Errata sheet LPC82x

Rev. 1.3 — 3 April 2018

| Info | Content |
|-----------------|---|
| Keywords | LPC824M201JHI33; LPC822M101JHI33; LPC824M201JDH20; LPC822M101JDH20; LPC82x errata |

Fig 1. Incorrect setting of RXIDLE during UART receive

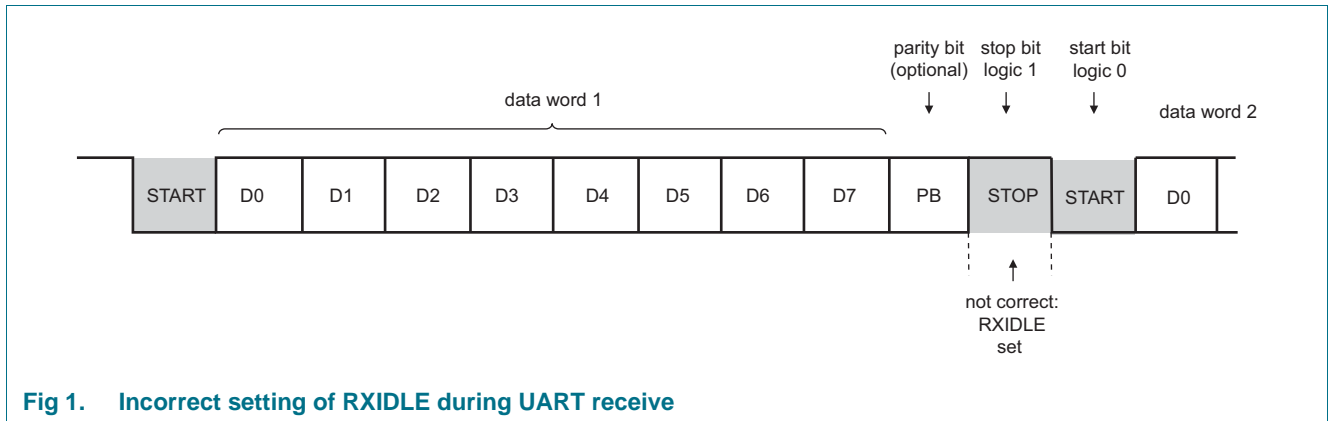
The RXIDLE bit is incorrectly set for a fraction of the clock cycle between the reception of the last data bit and the reception of the start bit of the next word, that is while the stop bit is received. RXIDLE is cleared at the beginning of the start bit.

When writing code that checks for the setting of any of the status bits RXIDLE, TXIDLE, TXDISSTAT, check the value of the status bit in the STAT register:

- If status bit = 1, add a delay of one UART bit time (if STOPLEN = 0, one stop bit) or two bit times (if STOPLEN = 1, two stop bits) and check the value of the status bit again:
 - If status bit = 1, the receiver is idle.
 - If status bit = 0, the receiver is receiving data.
- If the status bit = 0, the receiver is receiving data.

Fig 2. Incorrect setting of TXIDLE and TXDISSTAT during UART transmit

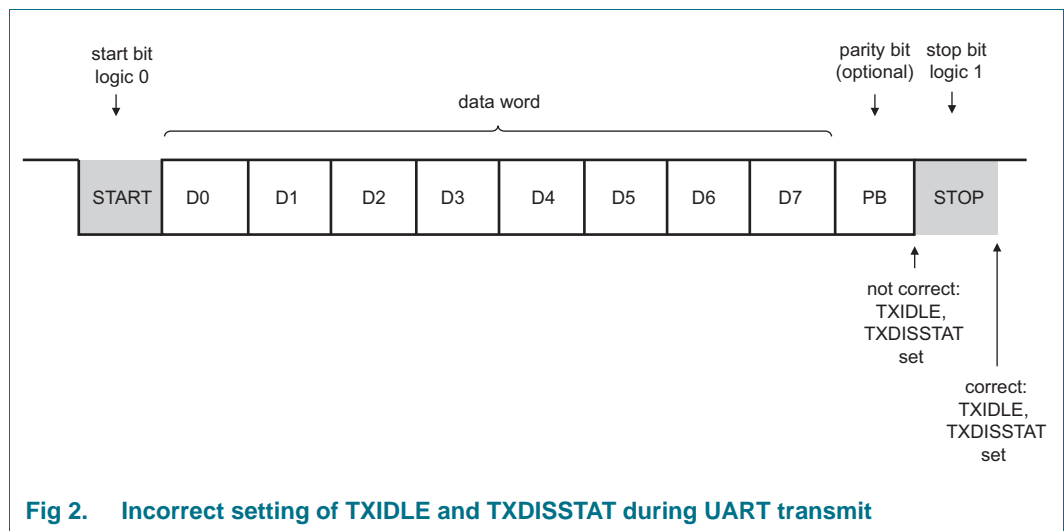
Both, TXIDLE and TXDISSTAT are set incorrectly between the last data bit and the stop bit while the transfer is still ongoing.
